SITE PLAN REVIEW

SPR - 95-70

Project Name: Office Warehouse

REVIEW COMMENTS

ATTACHMENT TO SITE PLAN - WELLS COMMERCIAL

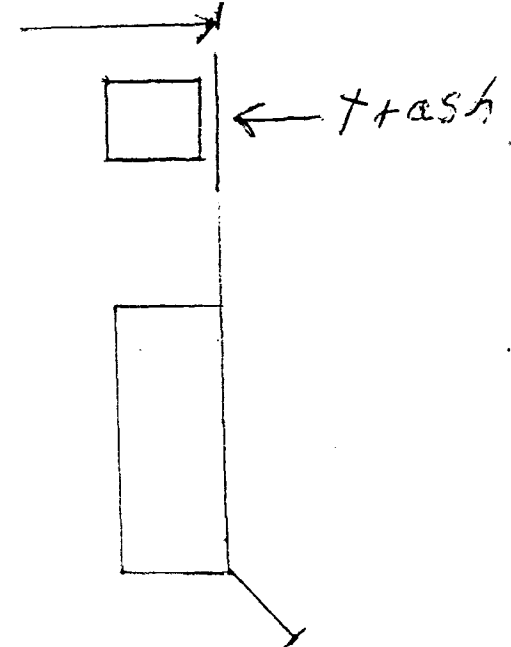
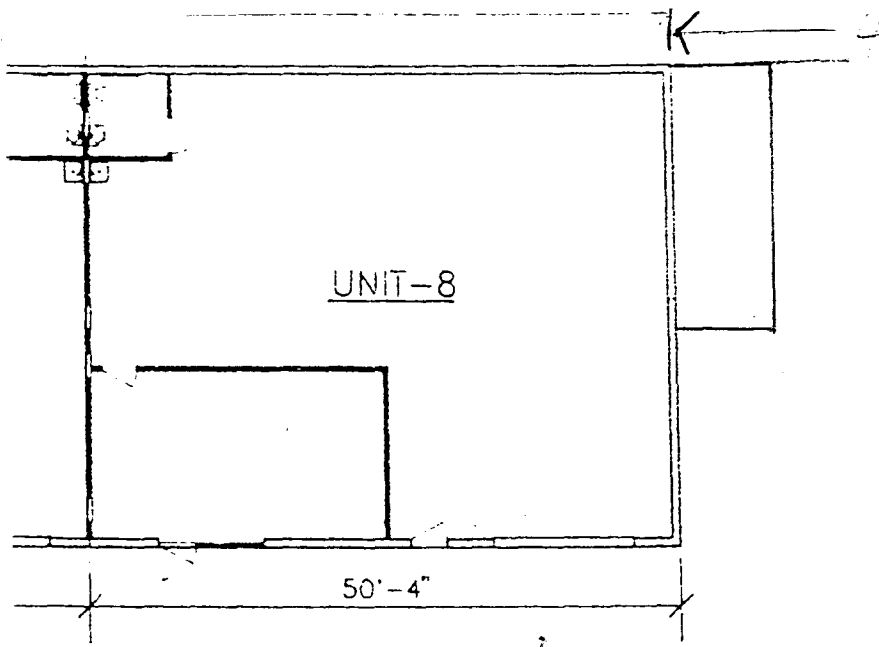
1. FIRE HYDRANT SHALL BE LOCATED SOUTH TO WITHIN 10 FEET OF SITE DRIVEWAY AS PER FIRE DEPARTMENT
